**Planning and Zoning Commission - Regular Meeting
October 1, 2026 - 5:30 PM**

26-2775 Consideration of a request from IPRR South Pointe-9, LLC for a Final Plat of Lot 1X and 2X, Block 1, Lot 1X, Block 2, Lot 1X, Block 3, and rights-of-way for Julian Feild Street, Largent Way, and Wagon Place, Southpointe Phase 9, being 18.68 acres located in the S.M. Blair Survey, Abstract Nos. 72 and 135, Johnson and Ellis Counties, Texas (SD#26-011)

26-2776 Consideration of a request from Maverick Development Partners, LLC for a Preliminary Plat of Lot 1, Block 1, and Lot 1, Block 2, 311 Smith Street Multi-Family Addition, being 10.961 acres located at 301, 302, 305, and 309 Smith Street (SD#26-027)

JULIAN FIELD STREET
LARGENT WAY
WAGON PLACE
RIGHT-OF-WAY DEDICATION
LOTS 1X, 2X, BLOCK 1
LOT 1X, BLOCK 2, LOT 1X, BLOCK 3

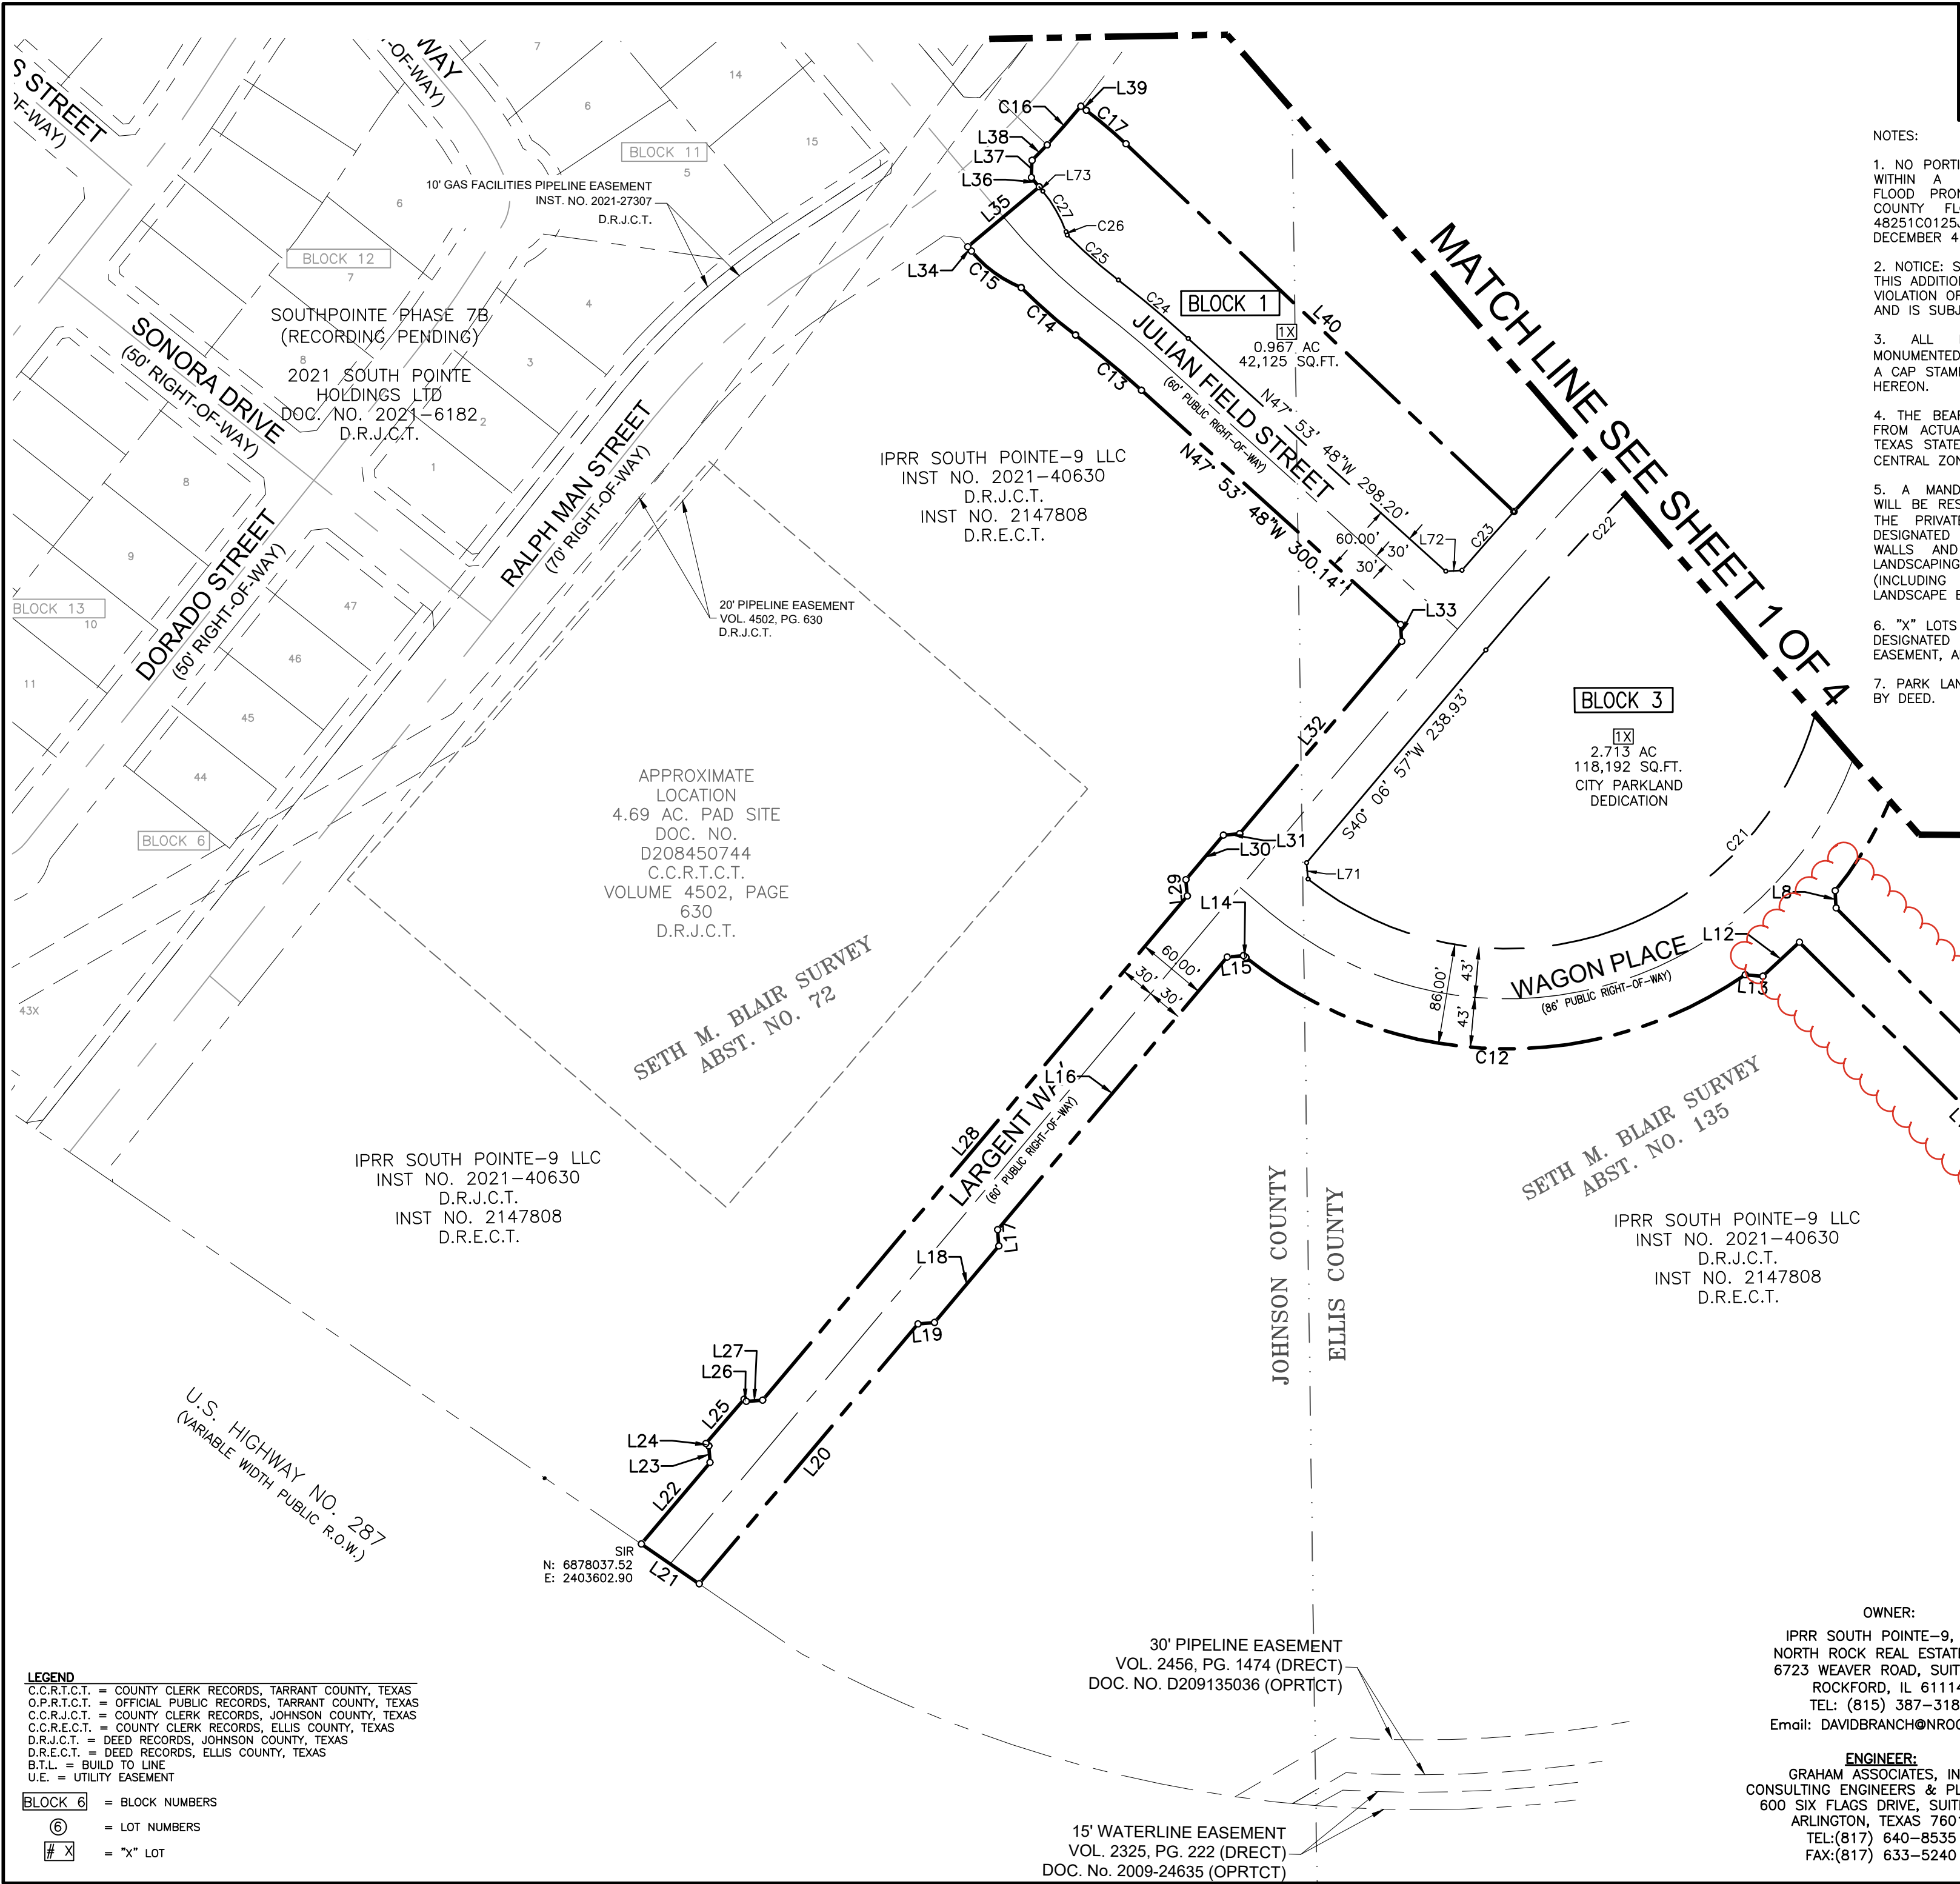
1. Add the case number (SD#26-011) under the title block. *Subdivision Control Ordinance §2.02(G)(1) (Requirements for case numbers)*
2. Label the lot number for Lot 1X, Block 2, on the graphic. *Subdivision Control Ordinance §2.02(G)(13) (Requirements for lot numbers)*
3. Remove the stub shown south of Wagon Place. Lines 9, 10, and 11 describe a private access easement and should not be part of the dedicated right-of-way on this plat. Ensure that the legal description closes correctly and correct the key map. *Subdivision Control Ordinance §2.02(G)(18) (Requirements for rights-of-way)*

4. Correct the spelling of Julian **Feild** Street on the plat and in the title block. *Subdivision Control Ordinance §2.02(G)(19) (Requirements for street names)*

6. Johnson County records each sheet separately. Add a Johnson County filing block on each sheet. ***Subdivision Control Ordinance §2.04(C)(7) (Requirements for filing blocks)***

FINAL PLAT

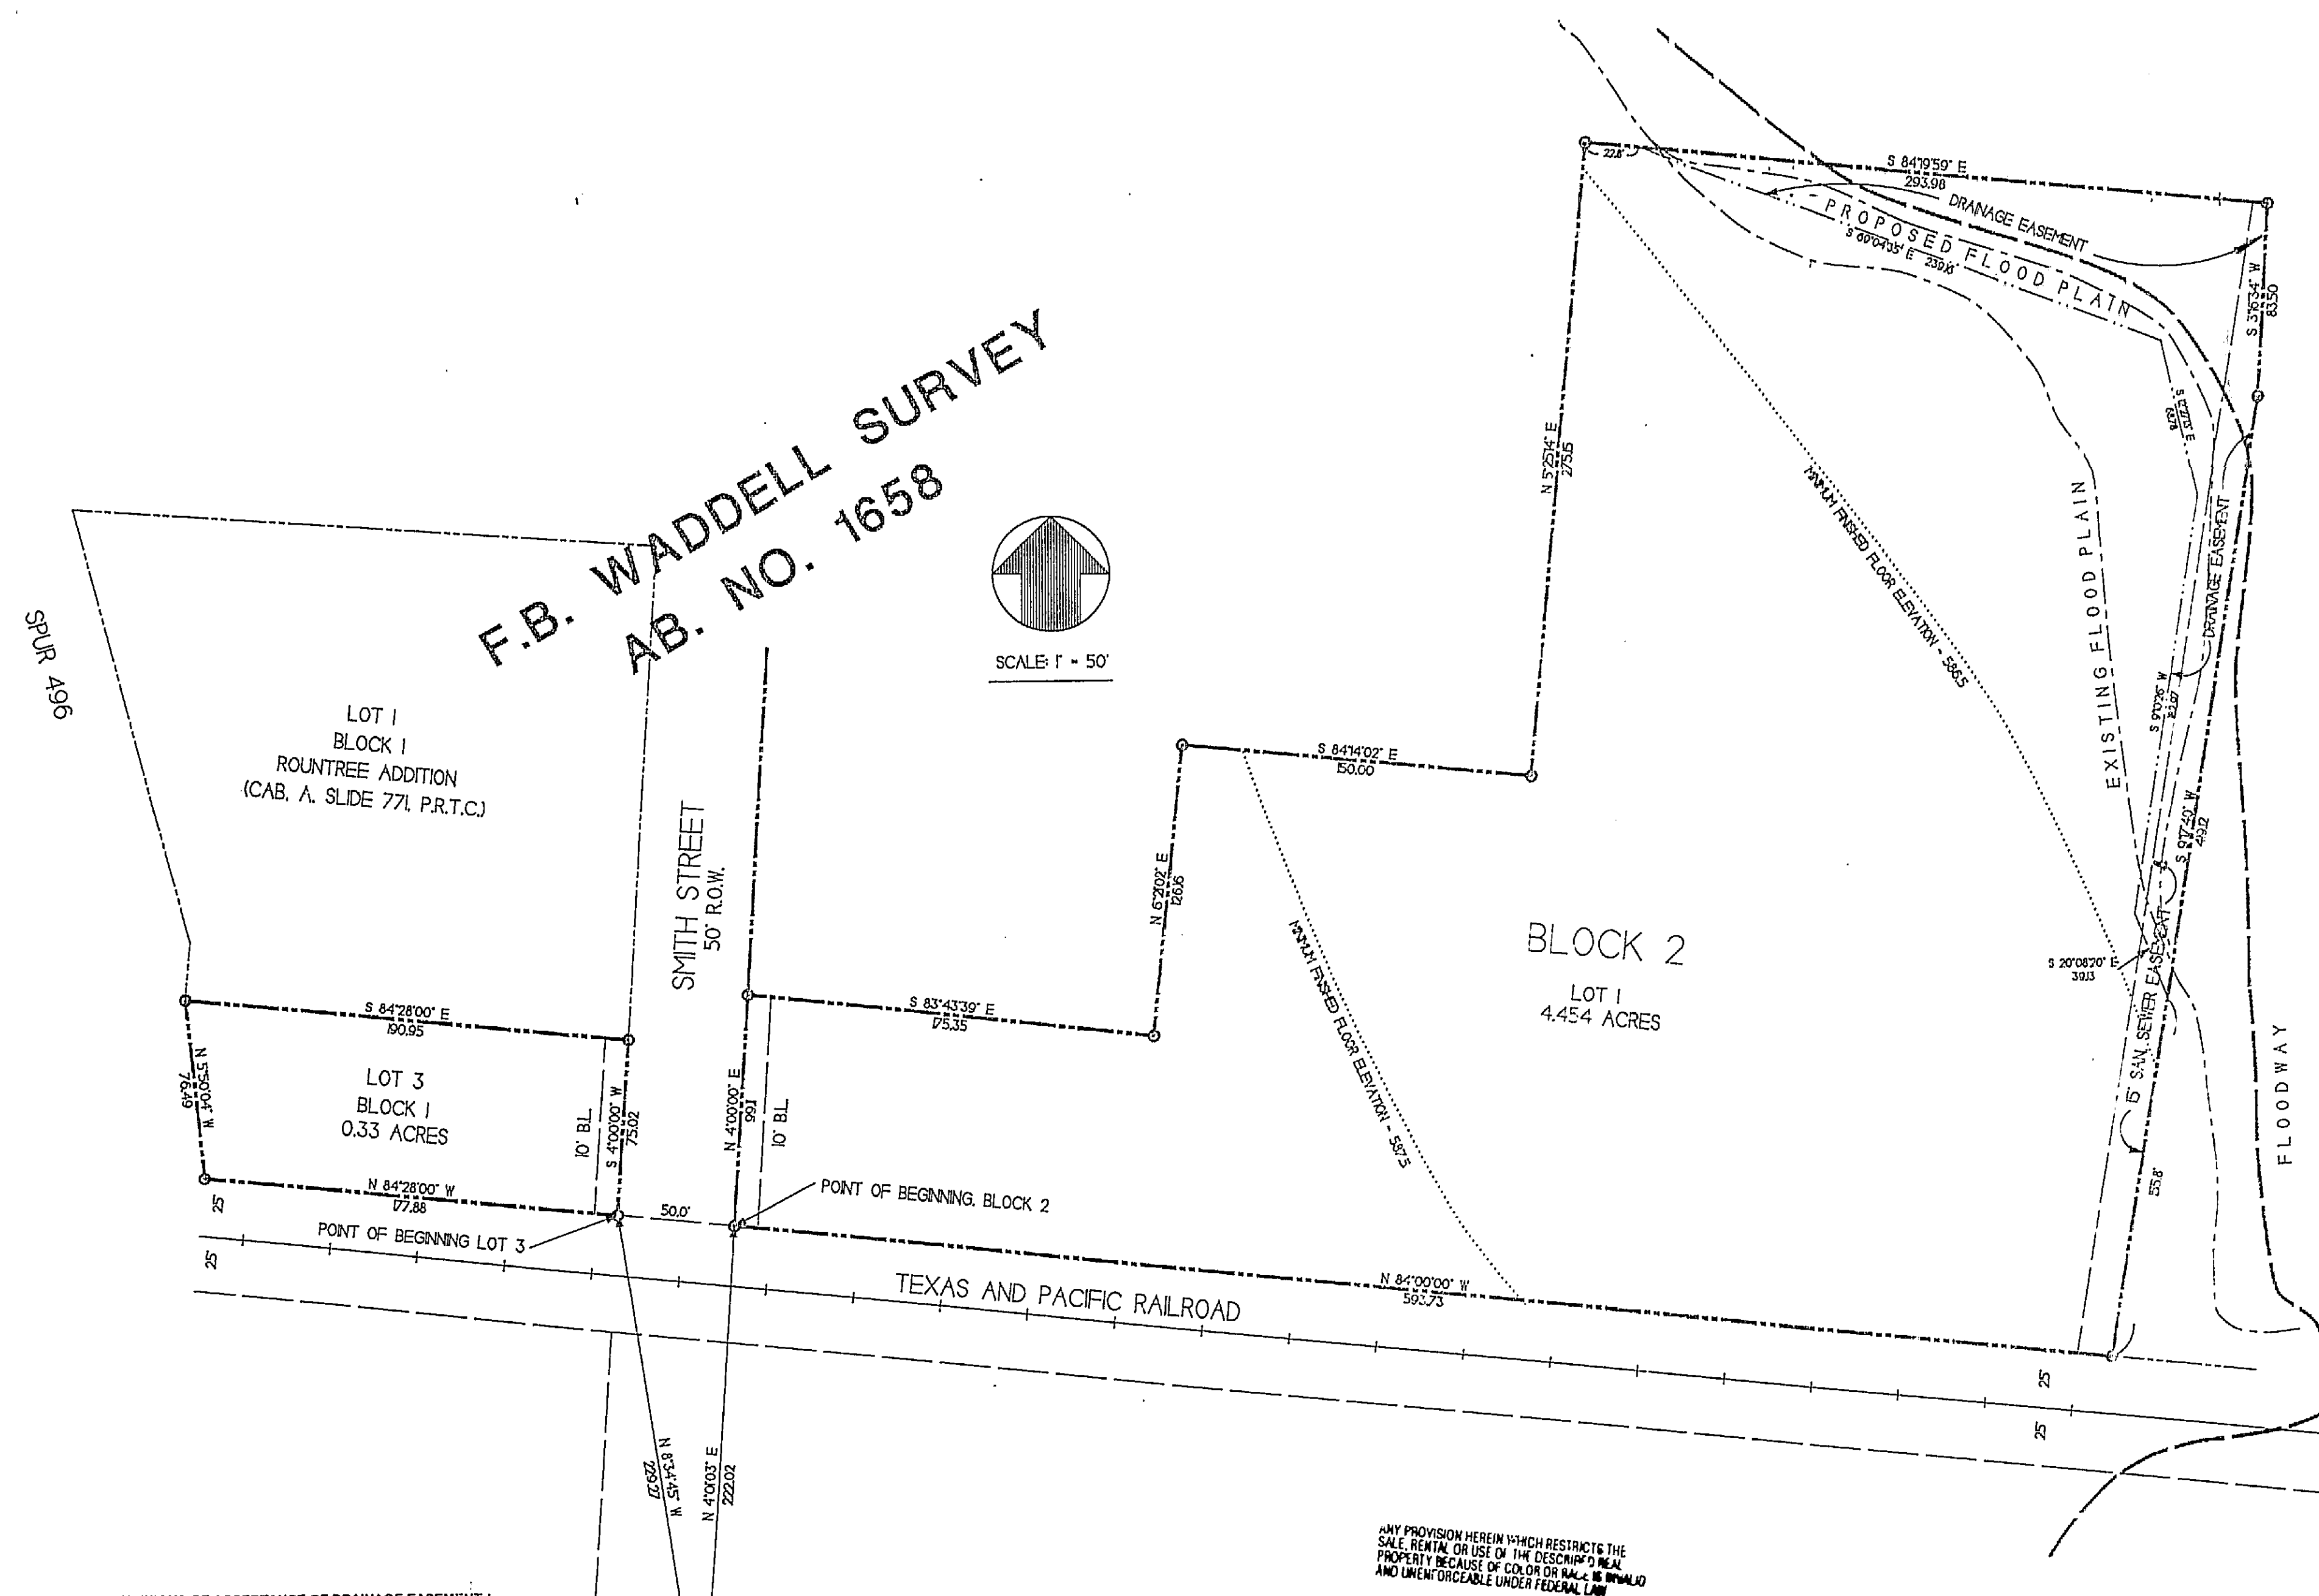
3. Provide the name of the record owner and deed recording information for all unplatted tracts within 200 feet, to include owners across any adjacent rights-of-way and all adjacent platted properties within 200 feet, shown in dashed lines, labeling the lot and block numbers, subdivision name, street names and plat record reference. ***Subdivision Control Ordinance §2.02(G)(7) (Requirements for adjacent properties)***

4. Show and label all existing and proposed easements on or adjacent to the subdivision as to type, size, and deed or plat record information. ***Subdivision Control Ordinance §2.02(G)(11) (Requirements for easements)***

5. Remove the recording information blank in the access easement label. Simply label it "By separate instrument". ***Subdivision Control Ordinance §2.02(G)(11) (Requirements for easements)***

7. Revise "This portion of Smith Street vacated per this plat" label to "To be abandoned". ***Subdivision Control Ordinance §2.02(G)(18) (Requirements for existing and proposed rights-of-way)***

8. Show the full and centerline dimensions of all streets on the plat and dimension the railroad right-of-way. ***Subdivision Control Ordinance §2.02(G)(18) (Requirements for existing and proposed rights-of-way)***

9. Show 10' utility easement along Smith St frontage. ***Subdivision Control Ordinance §2.02(G)(11) (Requirements for easements)***
10. Include Conditions of Drainage Acceptance on plat. ***Subdivision Control Ordinance §2.02(G)(11) (Requirements for easements)***

11. Remove the 500-year floodplain from plat. ***Subdivision Control Ordinance §2.02(G)(11) (Requirements for easements)***

12. Revise the floodplain label to read:

13. Add a note on the plat that references what study/FEMA map that the floodplain linework is referenced from. ***Subdivision Control Ordinance §2.02(G)(11) (Requirements for easements)***
14. The access easement will need to be labeled as “Common Access Easement”.
Subdivision Control Ordinance §2.02(G)(11) (Requirements for easements)
15. Provide notes on the plat stating the lots served by the Common Access Easement and who will maintain it:
 - a. The common access easement is for the use of Lots #, # and #. No improvements shall be made that impede ingress and egress along this easement.
 - b. The common access easement shall be maintained by [i.e. the property owners, a property owners association, etc.].
